Addendum 3
Solicitation 24-99198
Spirit Mountain Snowmobile Trail Construction

This addendum serves to notify all bidders of the following changes to the solicitation documents:

**SPIRIT MOUNTAIN
SNOWMOBILE TRAILS
CITY OF DULUTH, MINNESOTA**

3 PEDESTRIAN BRIDGE (SUPERSTRUCTURE)
6 NO SCALE

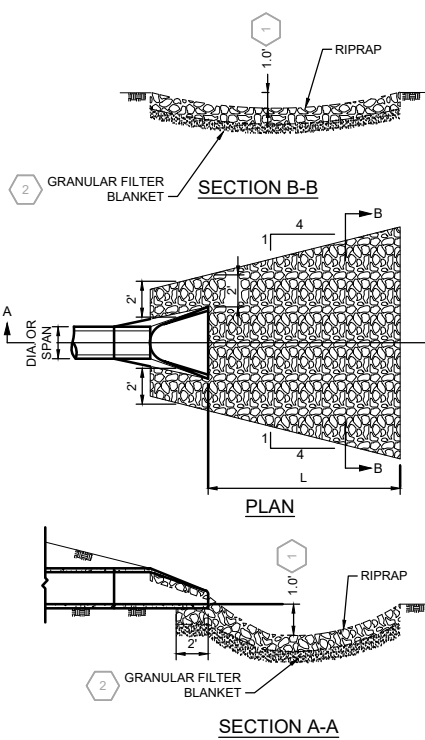
BRIDGE MATERIALS SCHEDULE			
ITEM DESCRIPTION	UNIT	TOTAL ESTIMATED QUANTITIES	NOTES
BRIDGE DECK SECTION	EACH	4	DIMENSIONS 8 FT X 16 FT
DECKING BOARDS	EACH	32	2X10 BOARDS, 8 FT LENGTHS
STRINGERS	EACH	7	2X10 BOARDS, 16 FT LENGTHS
TELEPHONE POLES	EACH	9	12 INCH AVERAGE DIAMETER, 32 FT LENGTHS

- CONSTRUCTION NOTES:
1. BRIDGE TO BE INSTALLED PER MN DNR TEMPORARY BRIDGE STANDARDS.
 2. CONTRACTOR UNIT PRICE TO INCLUDE TRANSPORT OF SALVAGED BRIDGE AND MATERIALS (SEE TABLE ABOVE), ABUTMENT TIMBERS AND TELEPHONE POLES FROM SPIRIT MOUNTAIN MAINTENANCE GARAGE TO BRIDGE SITE, PLACEMENT OF SALVAGED TIMBERS, INSTALLATION OF HELICAL PILE ANCHOR AND CABLE TETHER, AND CONSTRUCTION AND INSTALLATION OF TWO WOODEN PLANK RAMPS ON EACH SIDE OF BRIDGE.
 3. BRIDGE DECK SECTIONS SHALL BE PLACED SO THAT TWO SECTIONS ARE SIDE BY SIDE TO CREATE FINAL BRIDGE DECK DIMENSIONS OF 16 FT X 32 FT.
 4. CONTRACTOR SHALL USE THE DECKING BOARDS PROVIDED BY OWNER (SEE TABLE ABOVE) TO CONSTRUCT SALVAGED TIMBER RAMP ON EACH END OF BRIDGE.
 5. PROPOSED RAMP CONSTRUCTION, CONNECTION OF RAMP TO BRIDGE DECK, AND TETHER METHOD TO HELICAL PILE SHALL BE SUBMITTED TO CITY AND ENGINEER FOR APPROVAL PRIOR TO INSTALLATION.

NO.	DATE	BY	DESCRIPTION OF REVISIONS
2	2/7/24	ERM	ADDED BRIDGE INFORMATION AND NOTES
1	2/2/24	ERM	REVISED BRIDGE DETAIL

5 WIRE FENCE DESIGN 72V-9322

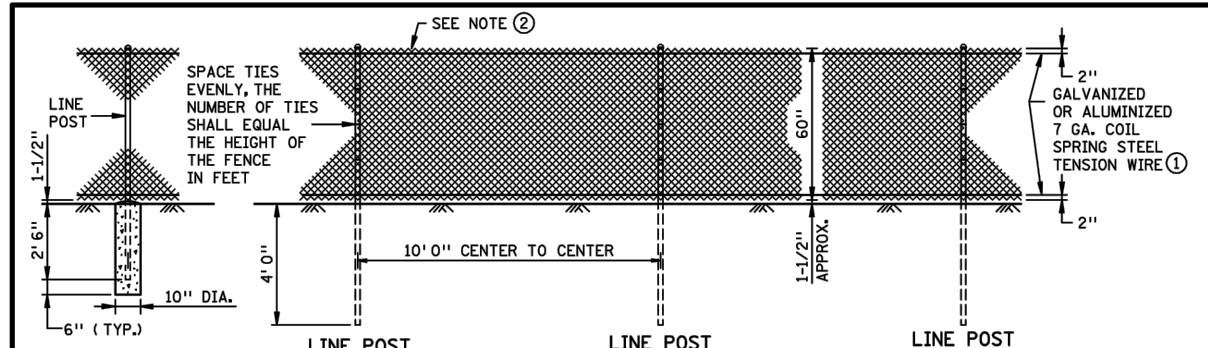
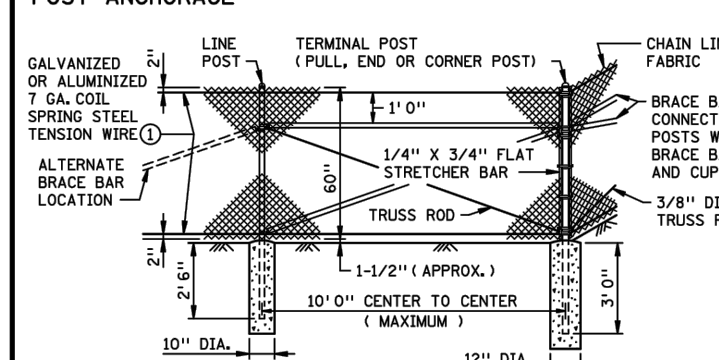
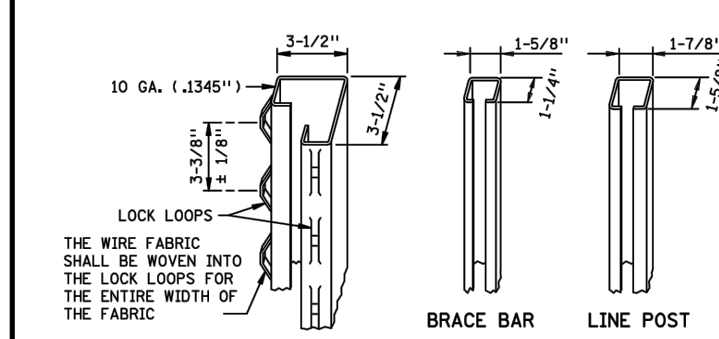
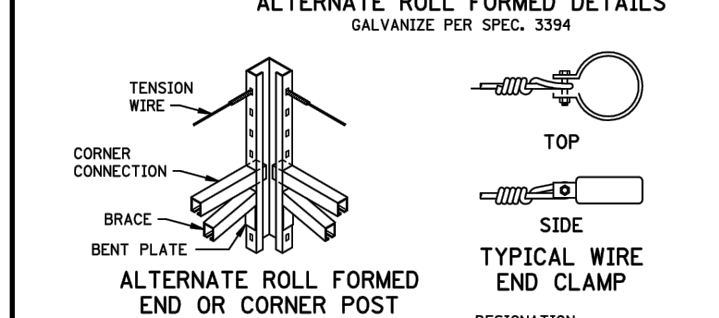
NO.	DATE	BY	DESCRIPTION OF REVISIONS
3	2/8/24	ERM	REVISED FENCE DETAIL, REMOVED GATE DETAIL
1	2/2/24	ERM	ADDED FENCE DETAIL
